Audi TT - Condensation in the headlamp | HELLA

Audi TT

Model year: 2006 - 2014

Condensation in the headlamp

Fig.1

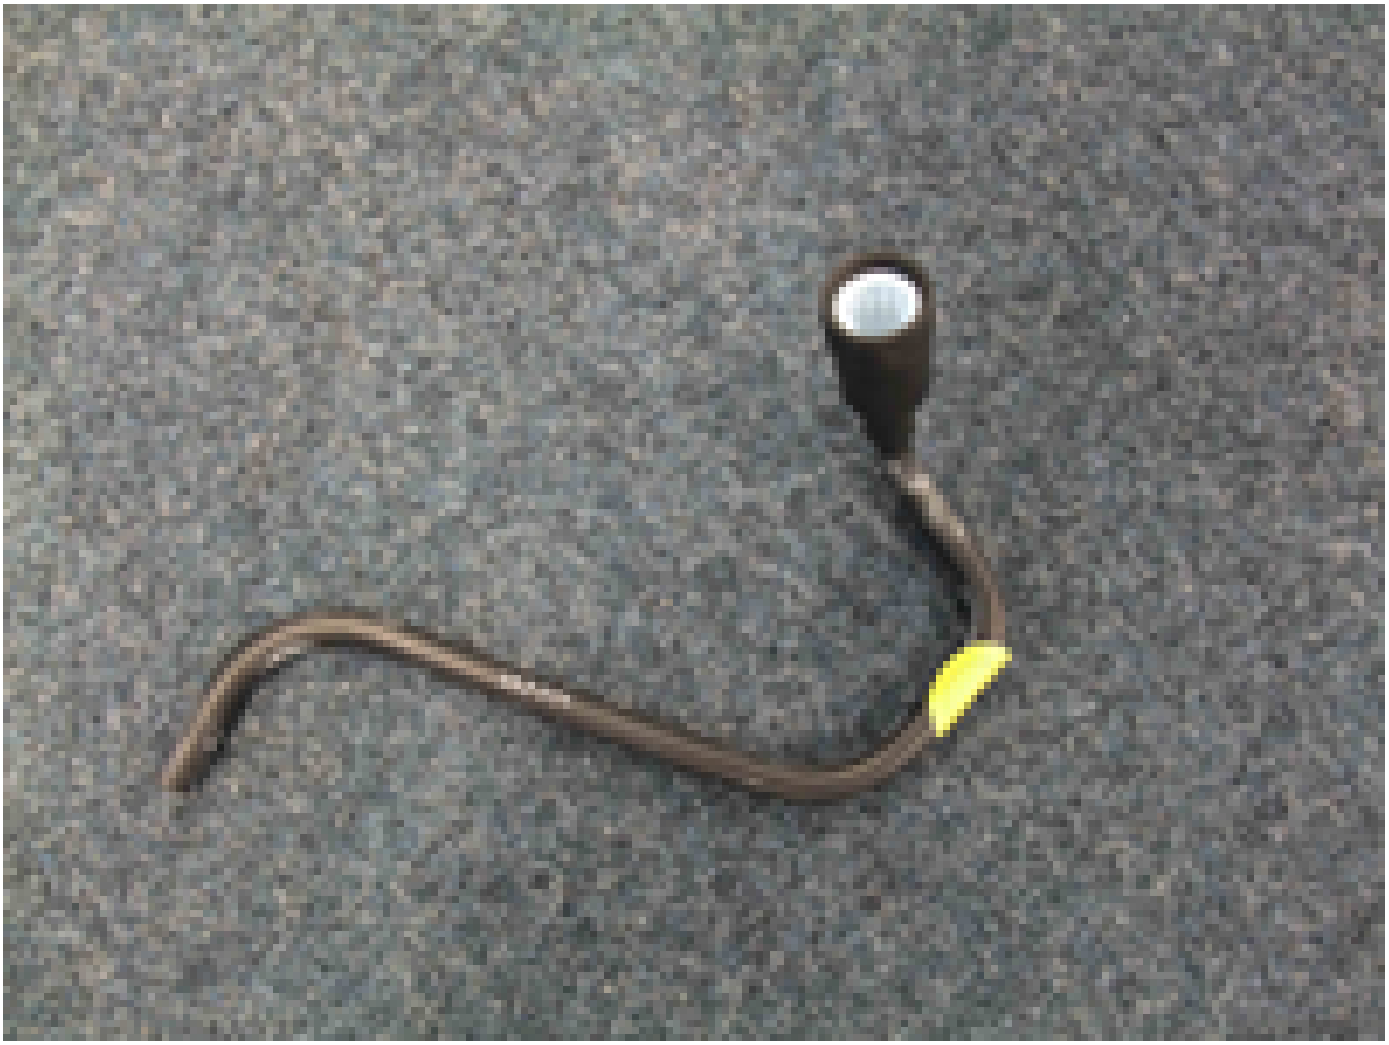
If the above-mentioned vehicle is found to have an extreme amount of condensation forming in the headlamps, the cause might be water entering through the ventilation hose.

In order to combat this, the vehicle manufacturer offers a modified hose, (Fig.1 / Fig.2), which is intended to reduce the high level of condensation. Another feature of this hose is that its shape governs the mounting position.

Parts no.: ventilation hose

Left: 8J0 941 717 B

Right: 8J0 941 718
